King's Daughters

KD-3123.0-26

GC Services for UK King's Daughters Medical Center – Greenup Co. Urgent Care/Family Care Medical Office Building

ADDENDUM # 02

E-301

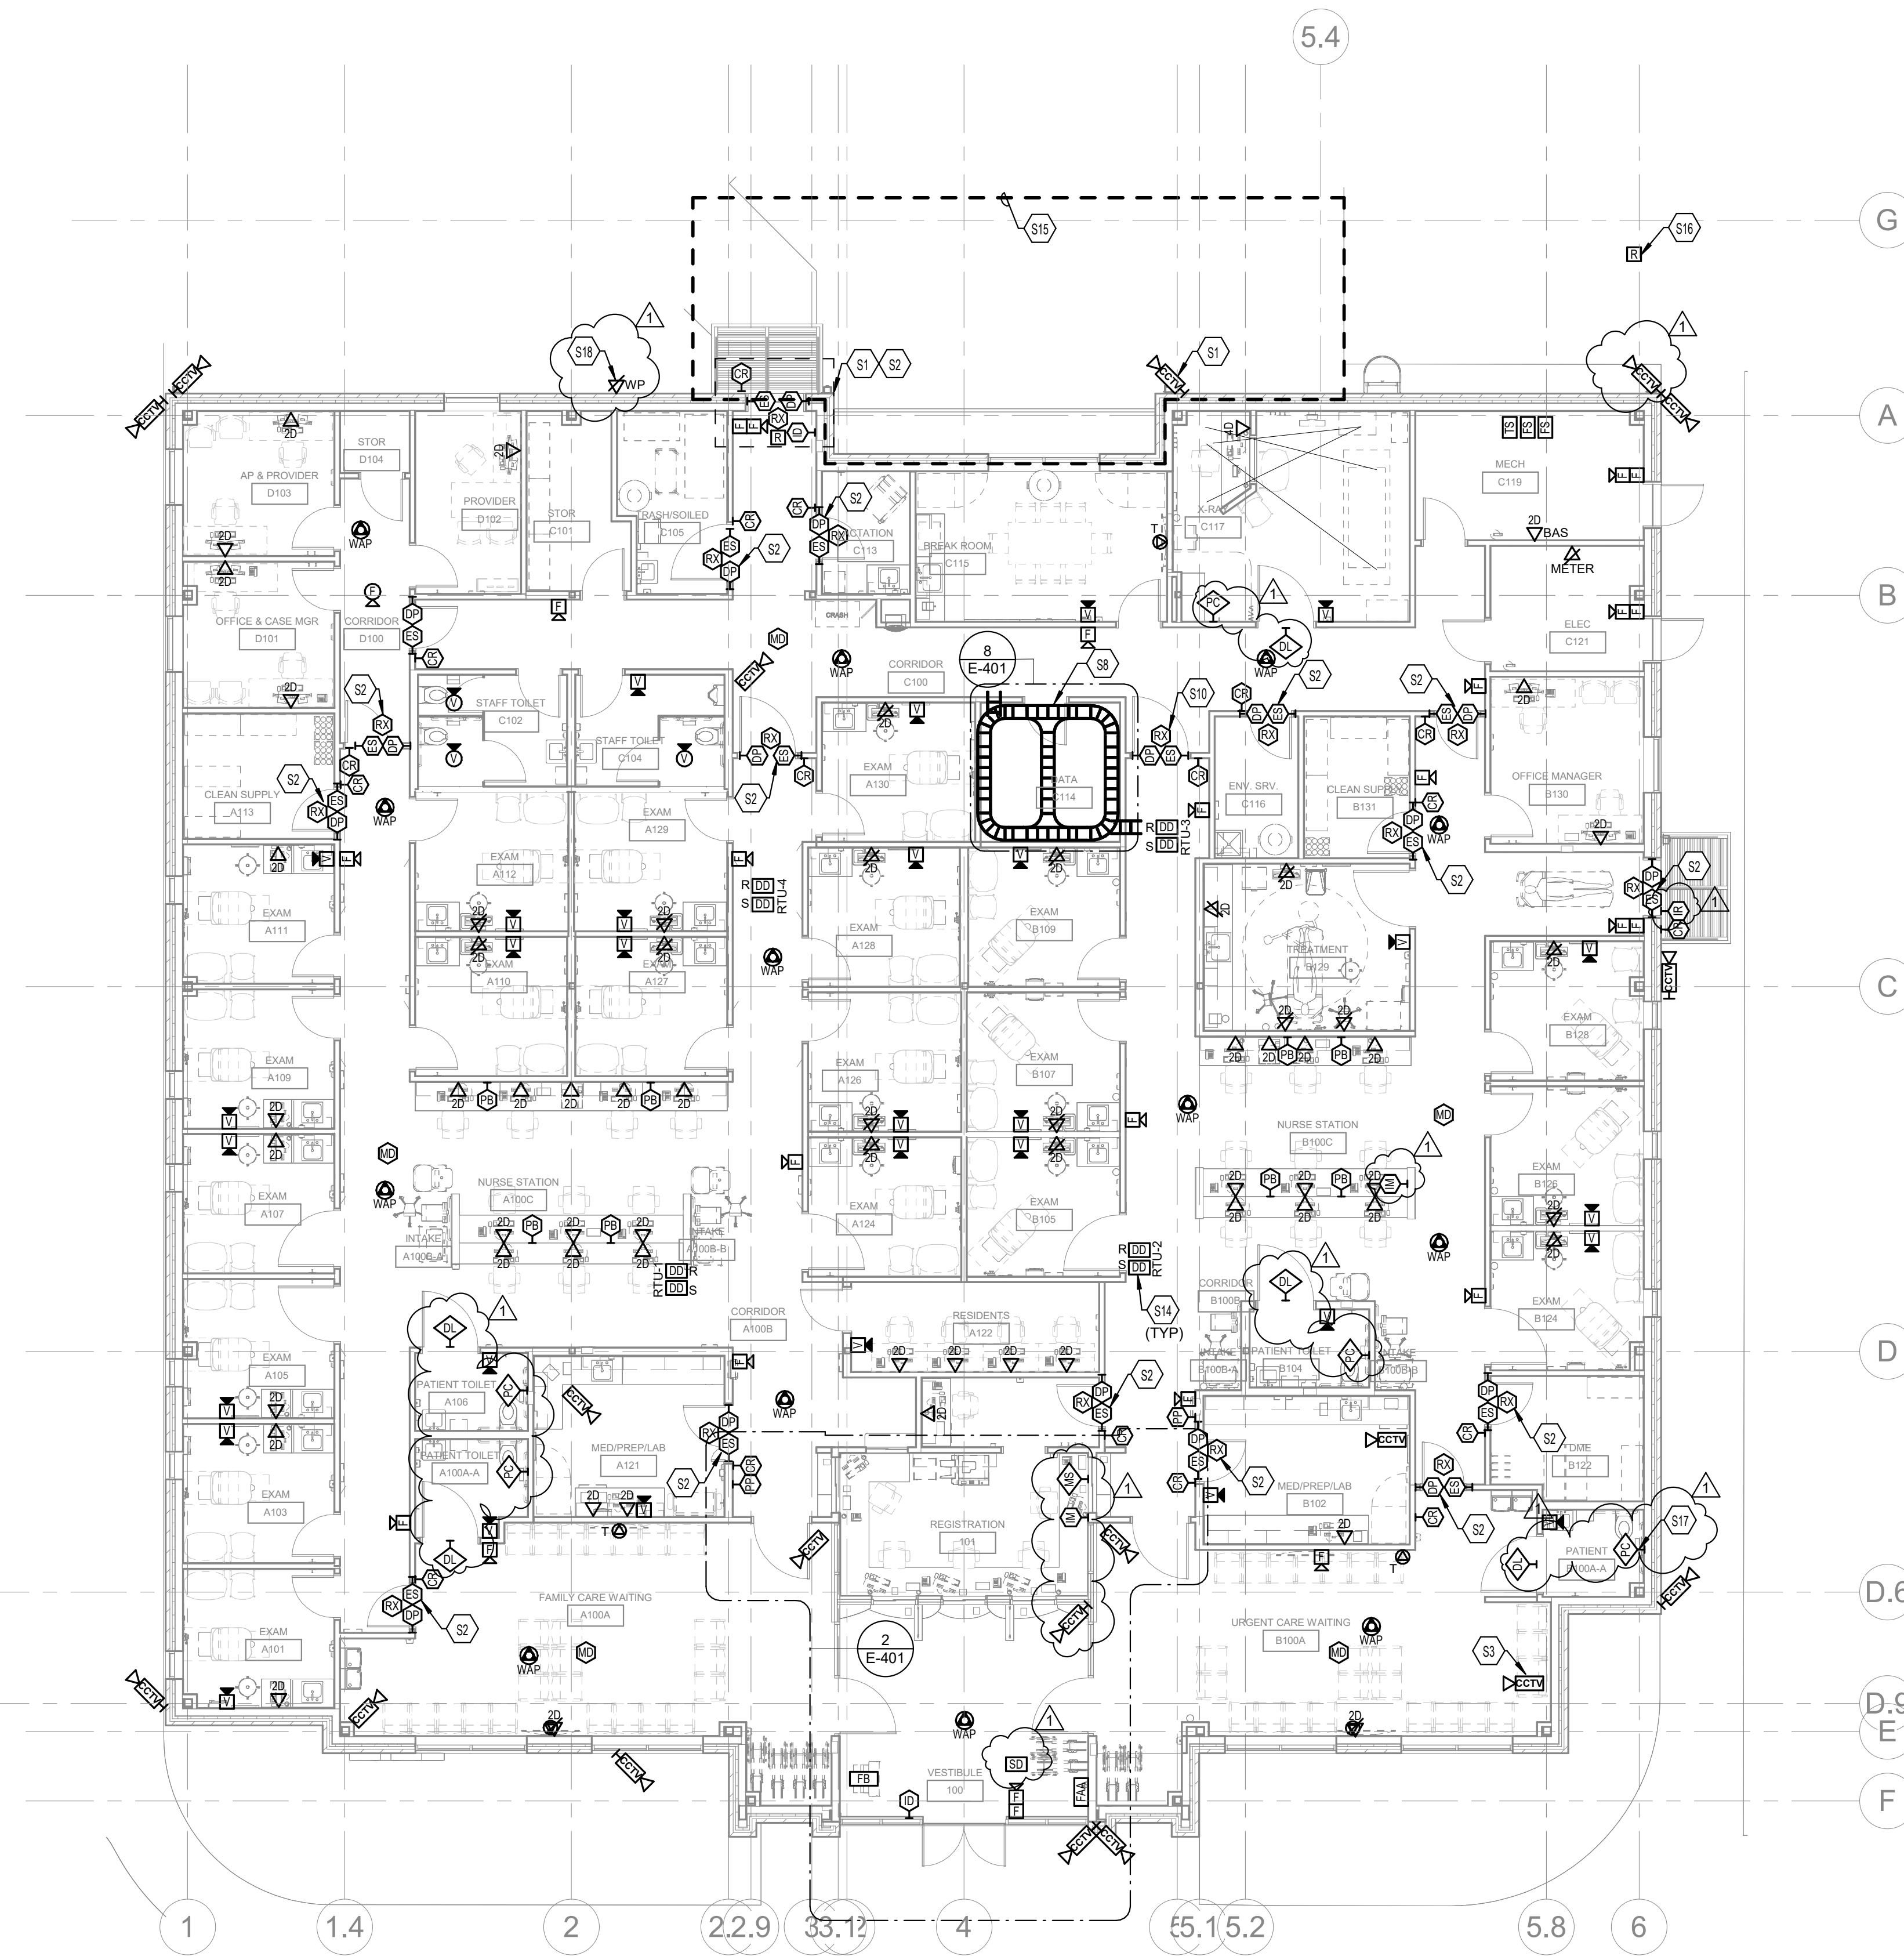
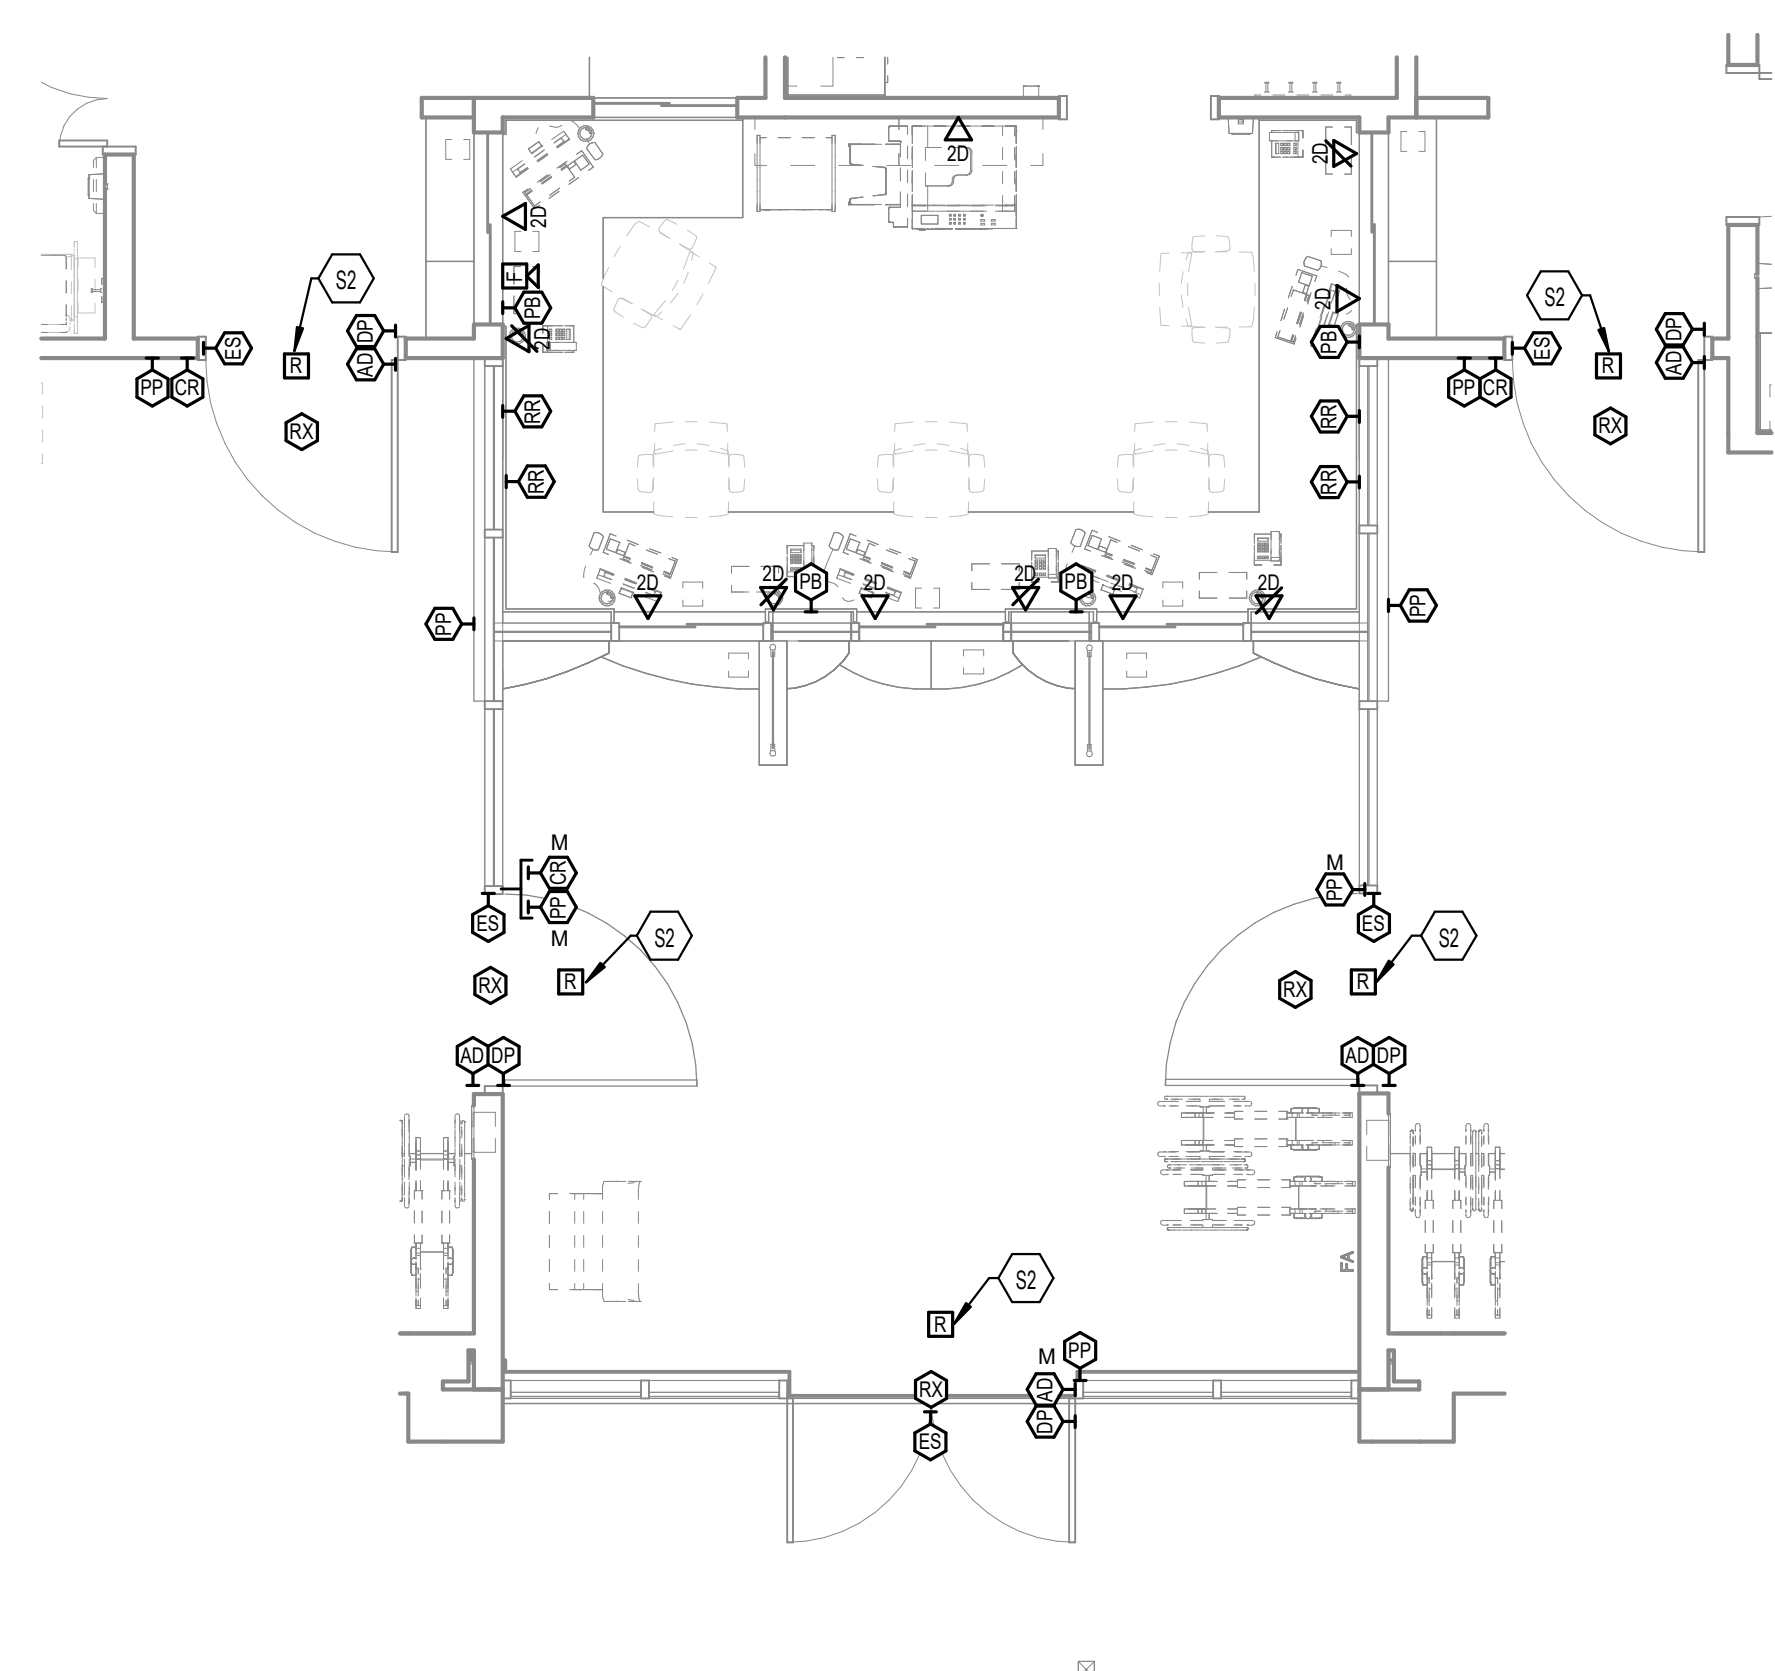
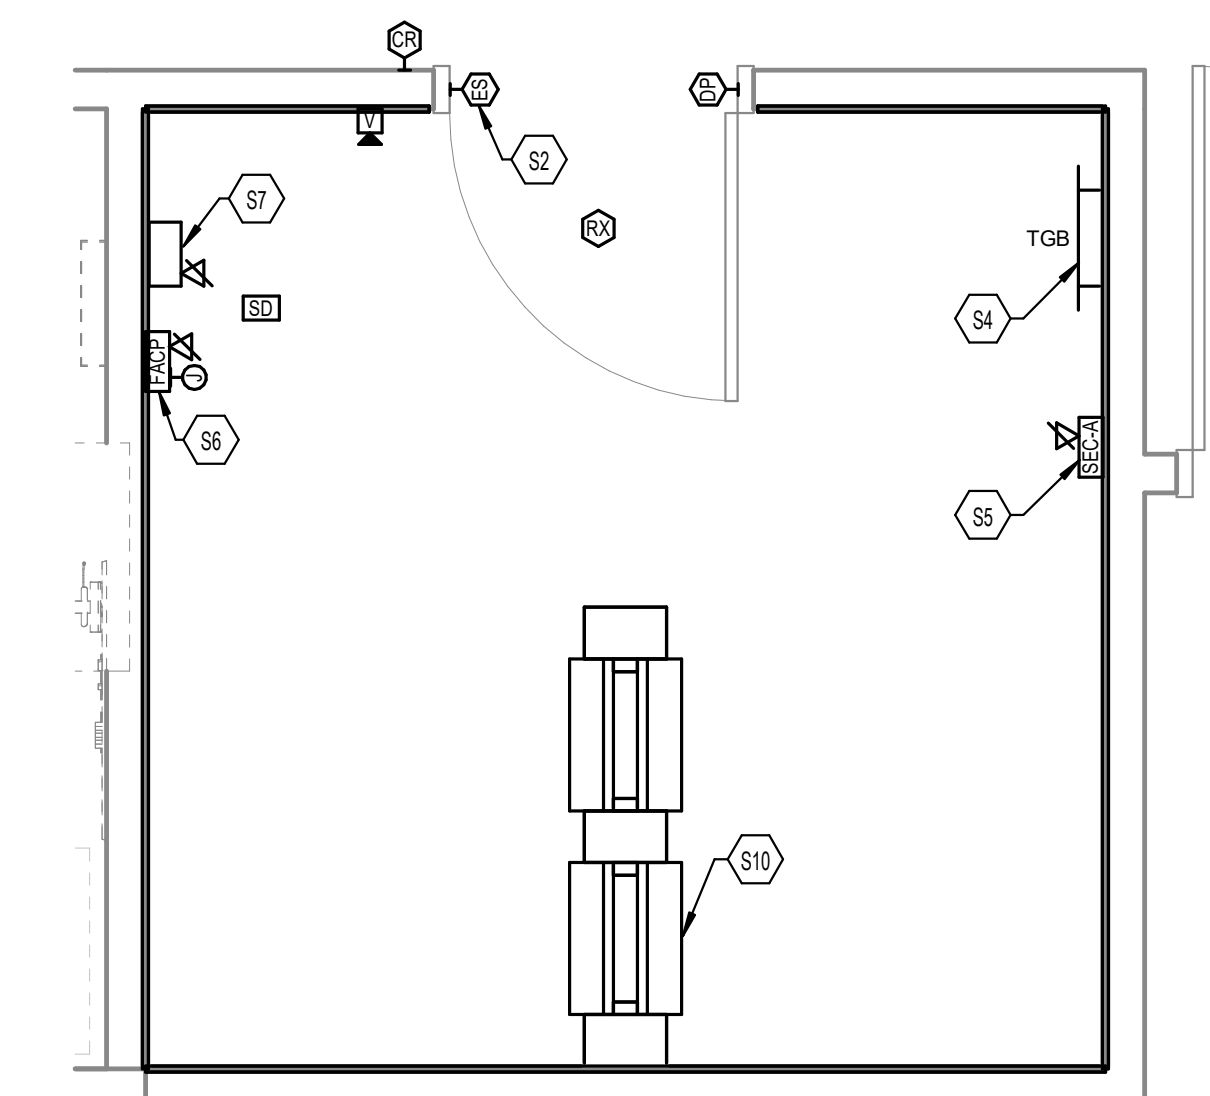
Refer to the attached revised Sheet – E-401 Systems Plan

- A new intercom station to be provided on exterior of Door B100B-E. Station to be AI-Phone Model IX-DV, or approved equal.
- Provide a new master intercom station at Nurse Station B100C with remote door release for Door B100B-E. Station to IXG-MK, or approved equal.
- Provide a new master intercom station at Registration 101 with remote door release for Door B100B-E. Station to IXG-MK, or approved equal.
- Additional camera location to be provided in Vestibule 100.
- Add nurse call pull stations and dome lights in each patient restroom and Xray with a master station at Registration 101.
- Added smoke detector in entry vestibule.
- Added exterior network connection for Mobile Mammography.

ONE-LINE DIAGRAM LINETYPE LEGEND

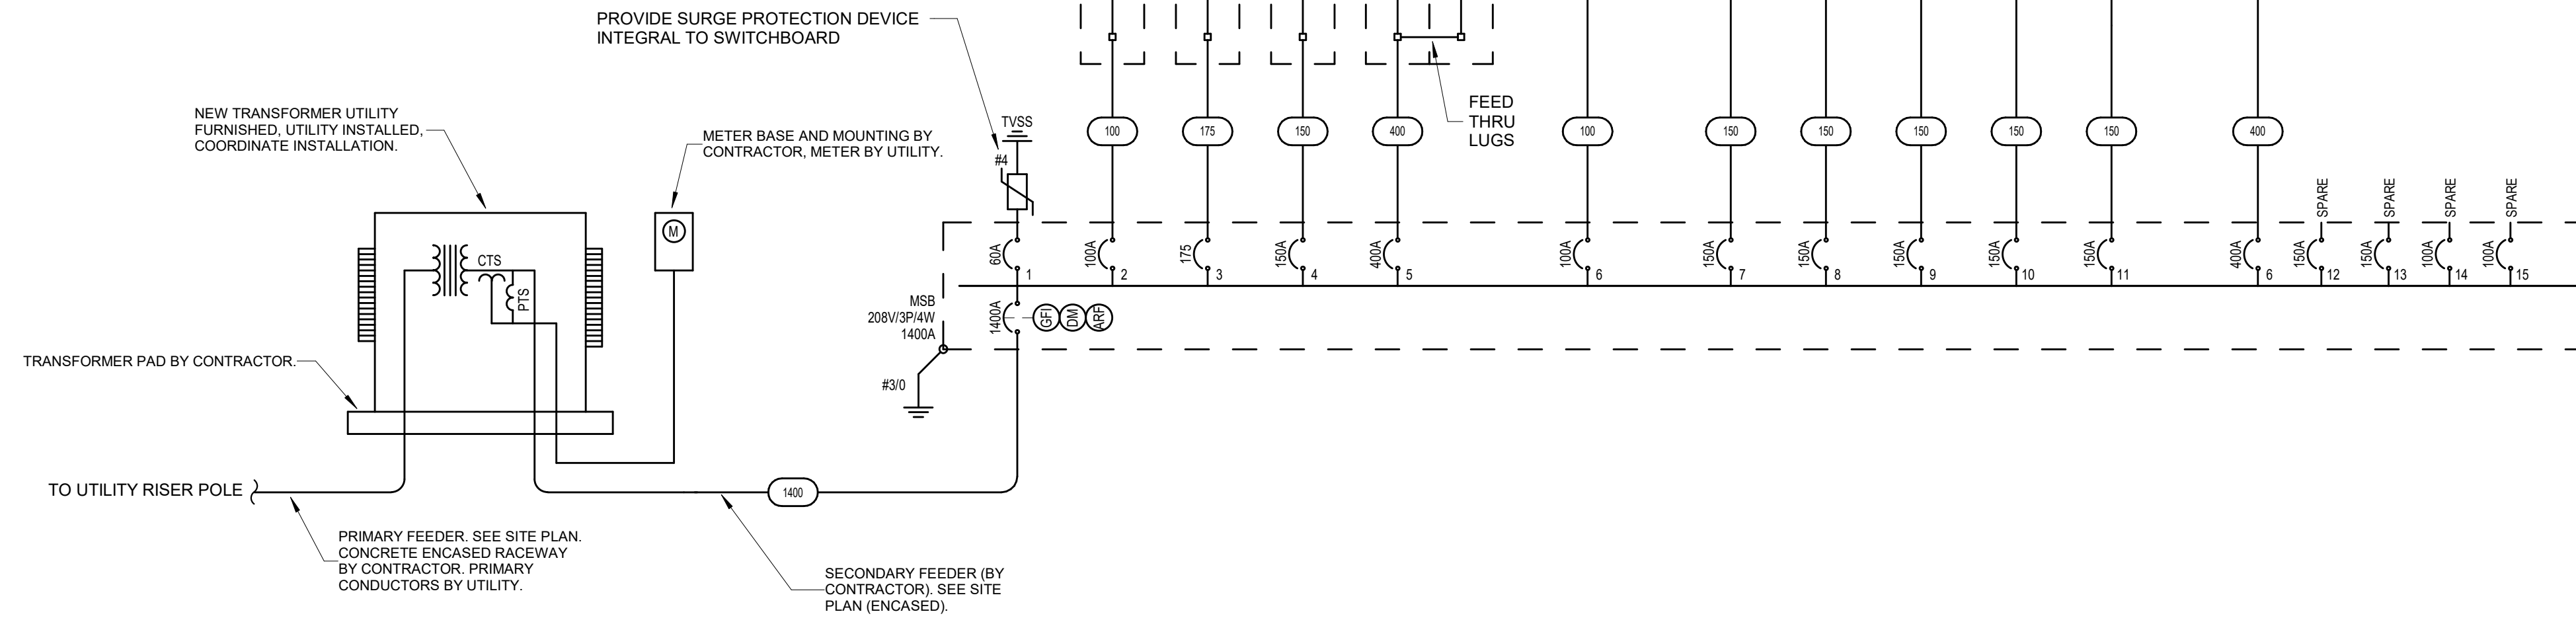
Refer to the attached revised Sheet E-501 One-Line Diagram/Panel Schedules

- Circuit for pediatric fridge removed.
- Switched circuit numbers for VAV-10 serving CT area.
- Renamed circuit for VAV-10 serving CT area to clarify it is part of alternate.
- Added circuit for unit heater in CT area.
